HISTORIC AND DESIGN REVIEW COMMISSION

June 19, 2019

HDRC CASE NO: 2018-631
ADDRESS: 321 N HACKBERRY ST
LEGAL DESCRIPTION: NCB 583 BLK 8 LOT 11
ZONING: IDZ, H
CITY COUNCIL DIST.: 2
DISTRICT: Dignowity Hill Historic District
APPLICANT: Roberto Elizondo
OWNER: Gabriela and Abel Marin
TYPE OF WORK: Construction of three, residential structures
APPLICATION RECEIVED: May 15, 2019
60-DAY REVIEW: July 14, 2019
CASE MANAGER: Edward Hall
REQUEST:

The applicant is requesting a Certificate of Appropriateness for approval to construct one, 2.5-story residential structure and two, 2-story residential structures on the vacant lot at 321 N Hackberry, located within the Dignowity Hill Historic District.

SITE PLAN
SCALE : 1/8"=1'-0"
(SCALE: 1/16"=1'-0" ON 11" X 17" SHEET)

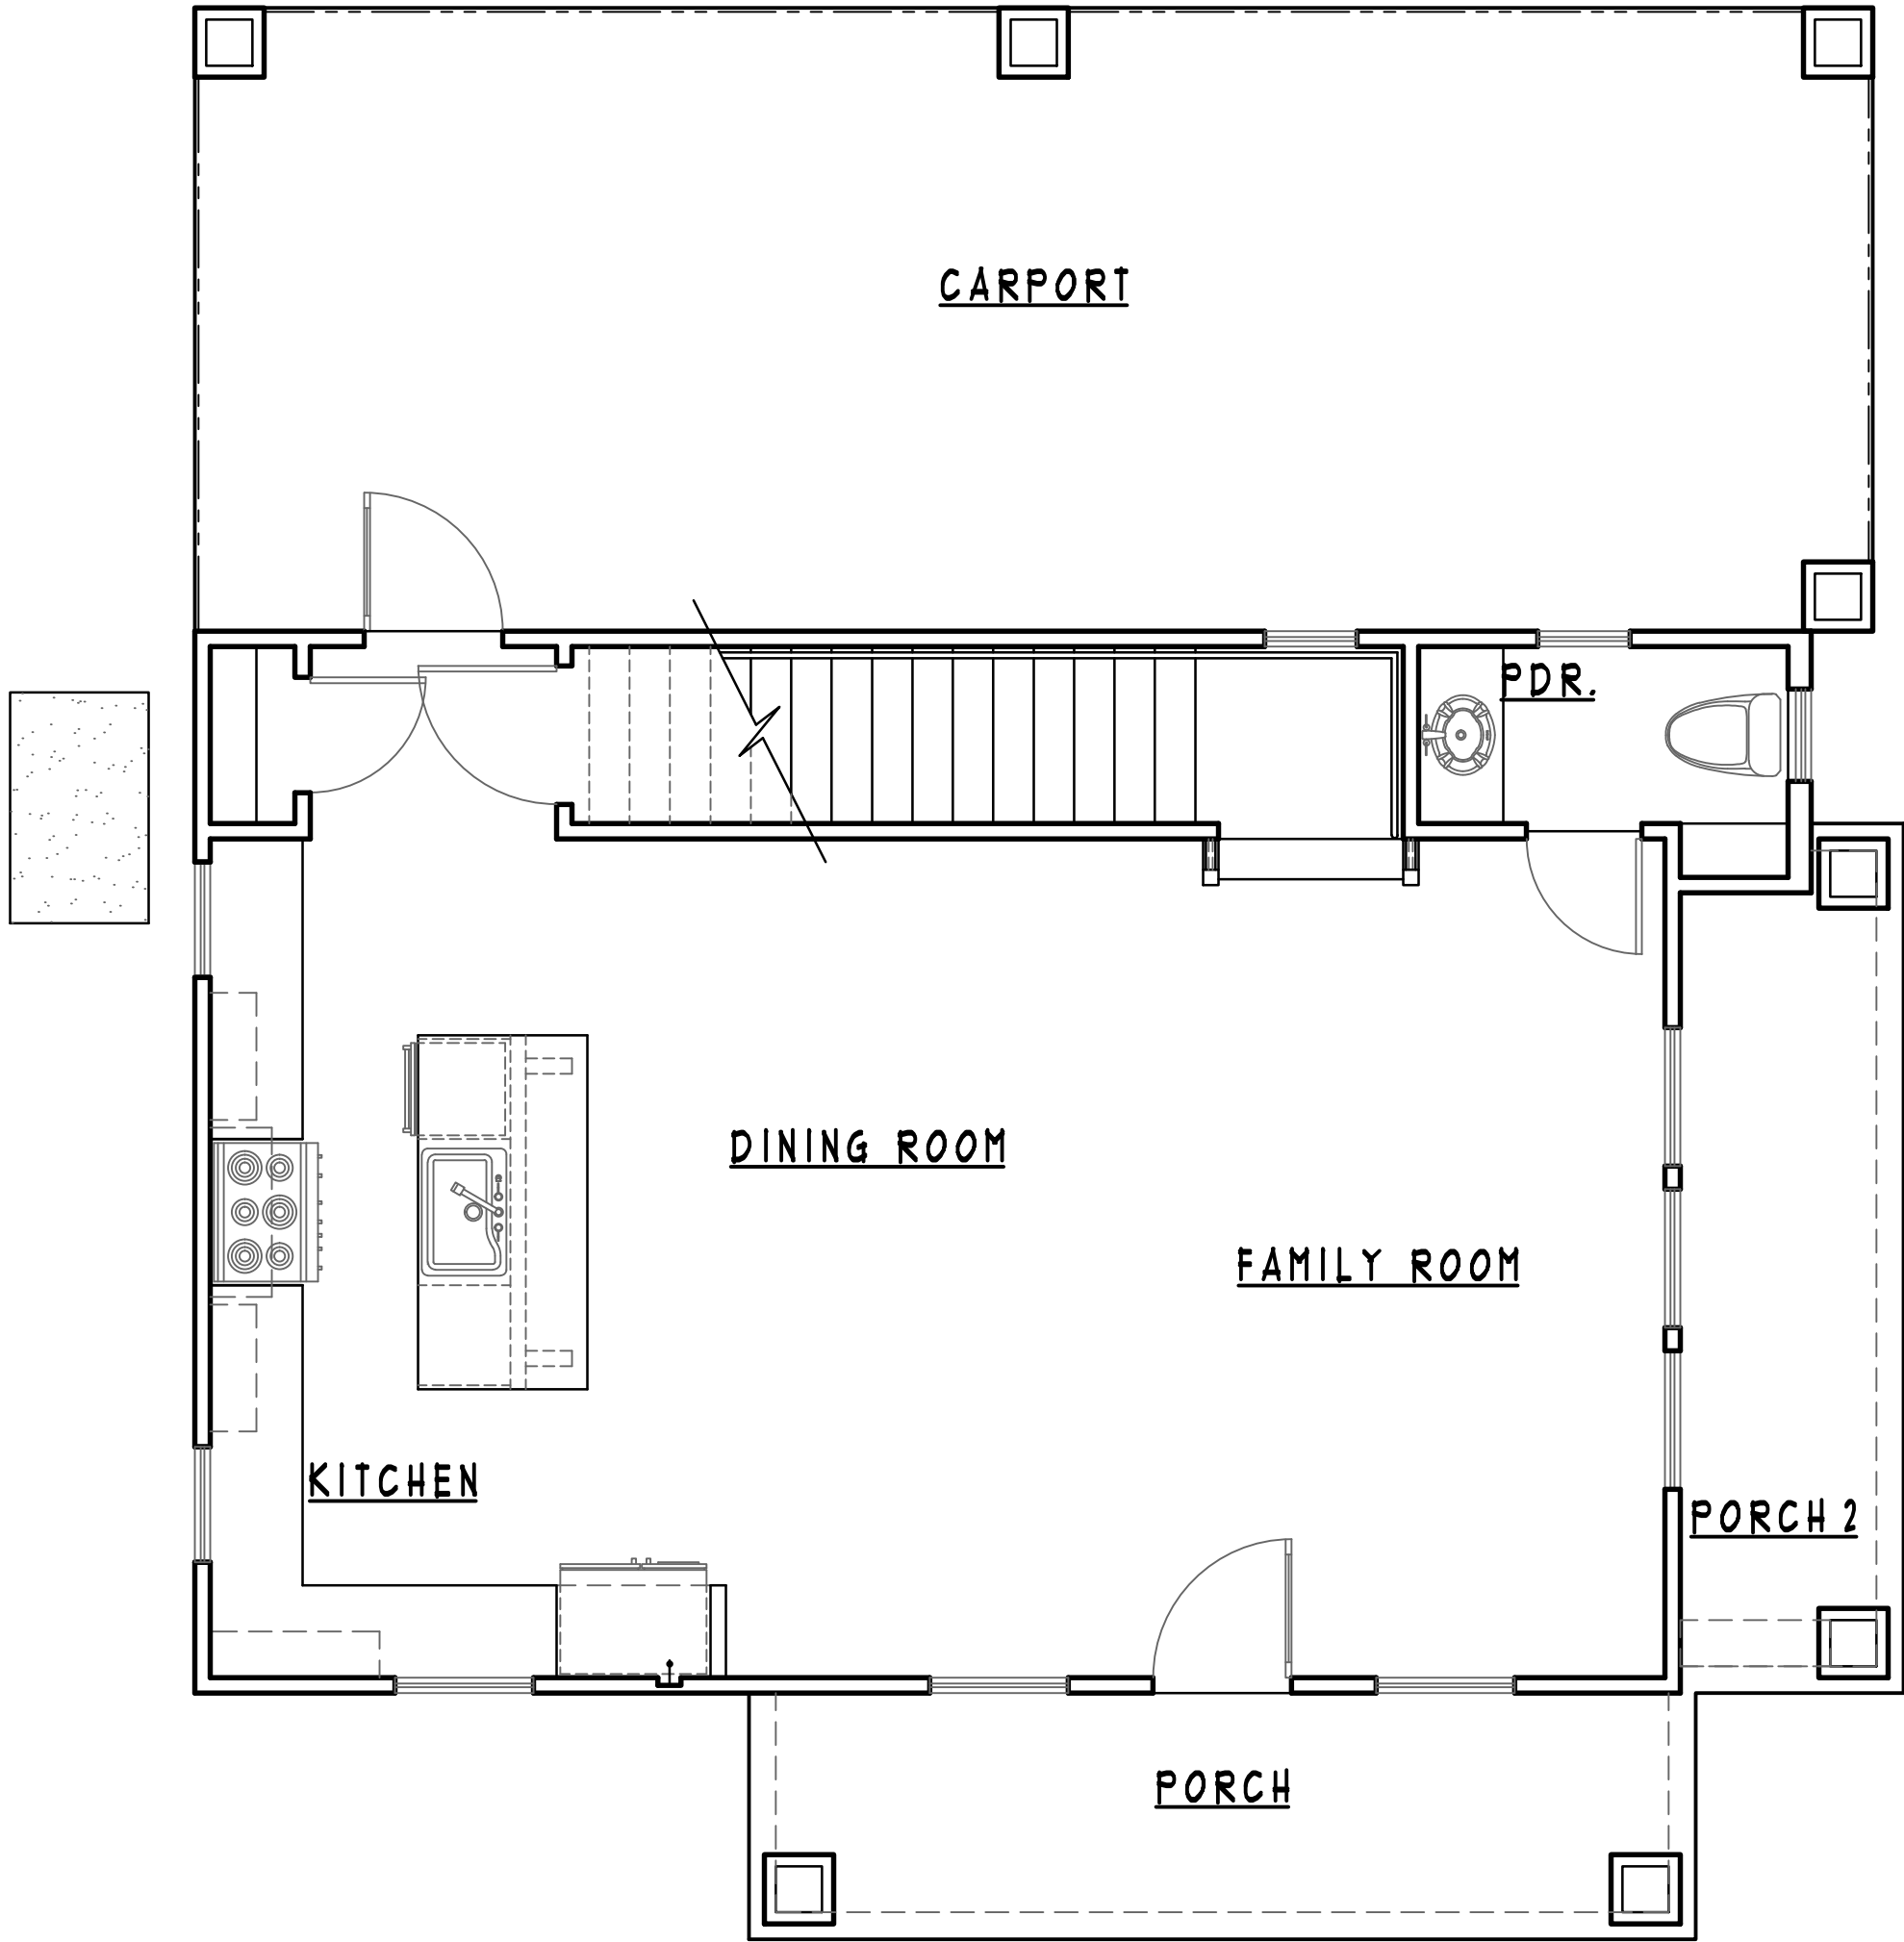
- l. **LOT COVERAGE** – Per the Guidelines, the building footprint for new construction should be no more than fifty (50) percent of the size of the total lot area. The applicant has noted the total size of the lot is 9,915 square feet. The applicant is proposing to construct three structures with a total footprint of 4,566 square feet. The applicant's proposed lot coverage is 46% coverage. This is consistent with the Guidelines.

- q. **DRIVEWAYS** – The applicant has proposed ribbon strip driveways for each structure, which lead to Armstrong Alley. The applicant should ensure that the proposed driveway widths do not exceed ten (10) feet.

- vii. That the proposed driveways do not exceed ten (10) feet in width.

FRONT ELEVATION

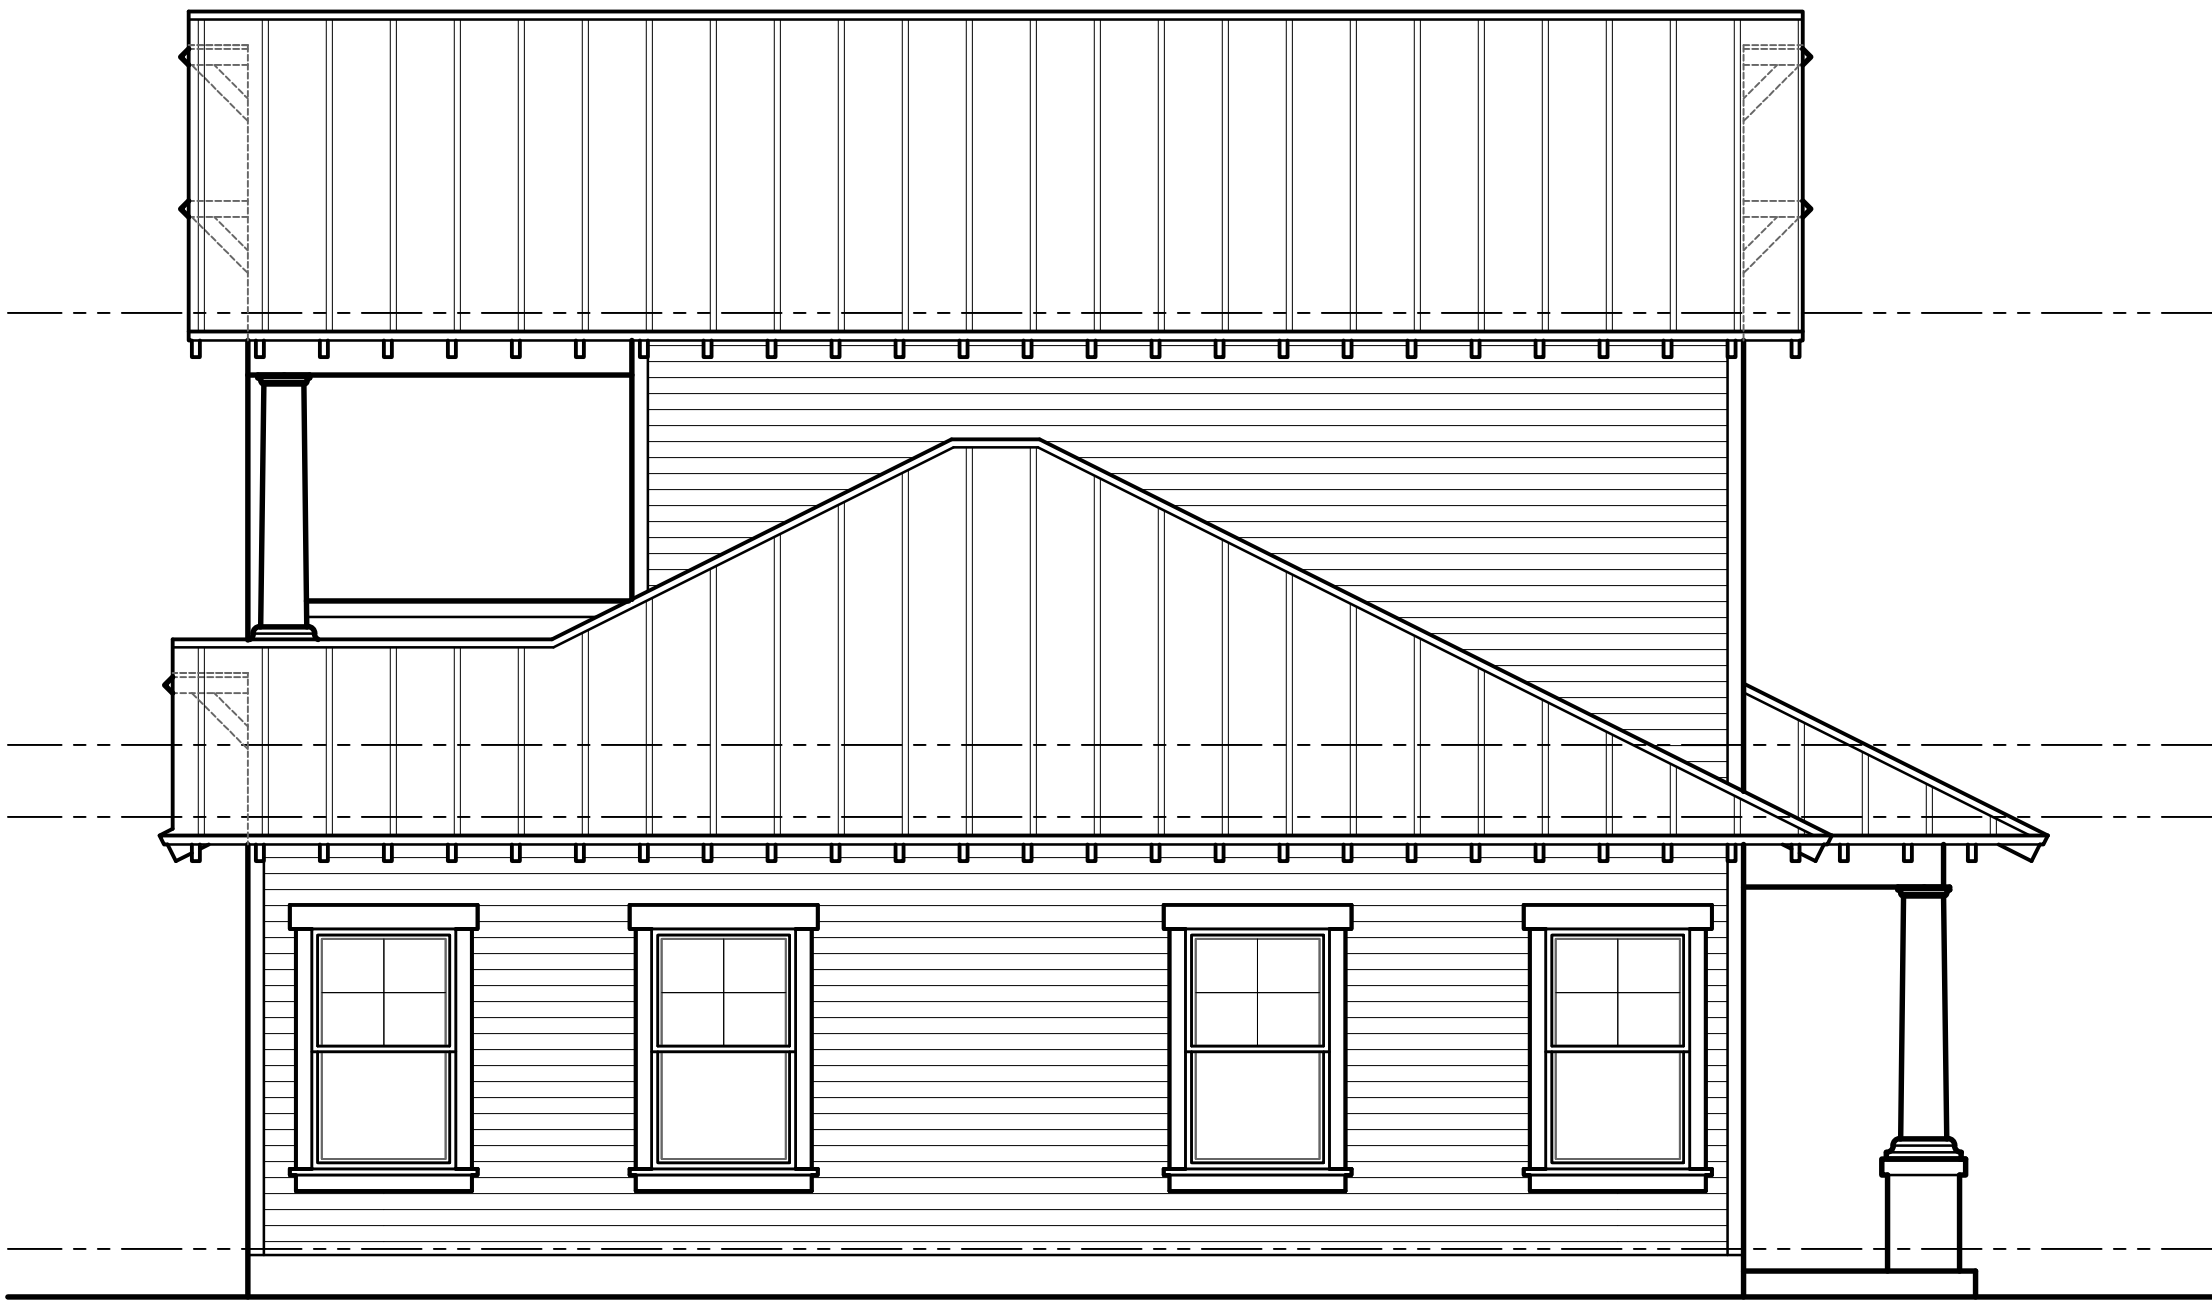
- h. **SCALE & MASSING** – The Guidelines for New Construction 2.A. notes that the height and scale of new construction should not exceed that of the majority of historic buildings by more than one-story. The applicant has noted a height of thirty-five (35) feet for the structure on N Hackberry, consistent with the neighboring historic structure's height. The applicant has proposed a height of twenty-six (26) feet for the two rear structures. Other homes oriented toward the alley are single-story. Staff finds that the applicant should explore ways to reduce the overall building height of the two rear structures to be more similar in height to those found historically on the alley.

JB: HEIGHT ~~WAS~~ HAS BEEN REDUCED TO 23'-11", HEIGHT CANNOT BE REDUCED TO ONLY ONE STORY IN HEIGHT,

ZH: HEIGHT SHOULD BE REDUCED (ALLEY UNITS); CONSIDER 1.5 STORIES RATHER THAN 2 STORIES.

JL: MAKE AN EFFORT TO REDUCE HEIGHT,

- ii. That the applicant comply with foundation height requirements as noted in finding h.
- iii. That the applicant explore shorter alley building heights to be similar in height to those found historically on the alley.
